TECHNICAL SERVICE BULLETIN

4WD - 6R100 - Metallic Grinding Noise Under Light Acceleration Between 23-33 MPH (37-53 Km/H) - Built On 01-Feb-2021 And Through 16-May-2022

22-2199

17 May 2022

Figure 1

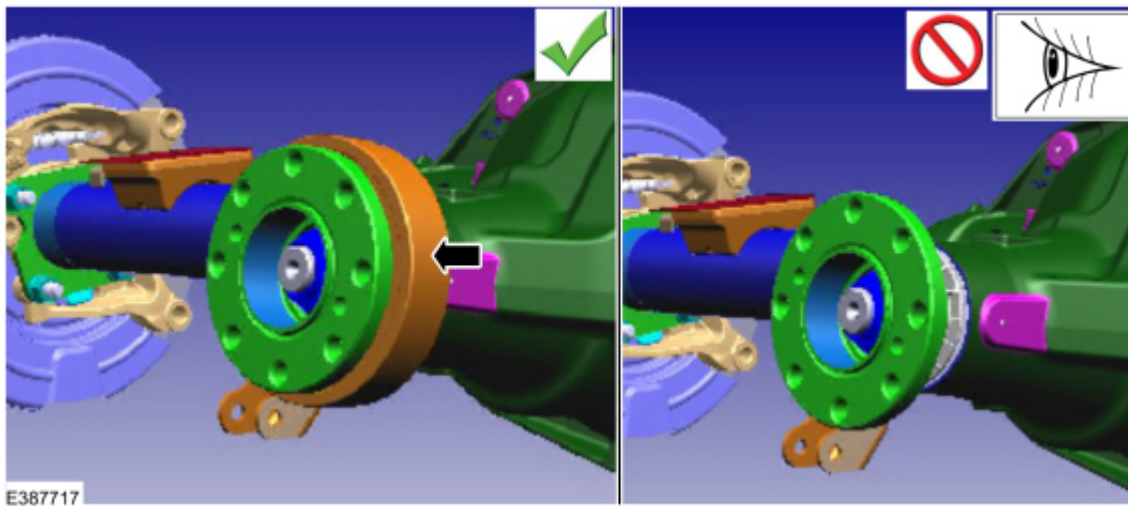
1. Inspect the rear axle pinion flange for the presence of a sound damper. Is a damper present? (Figure 1)

(1). Yes - proceed to Step 2.

(2). No - replace the rear axle pinion flange and rear pinion seal. Refer to Workshop Manual (WSM), Section 205-02.
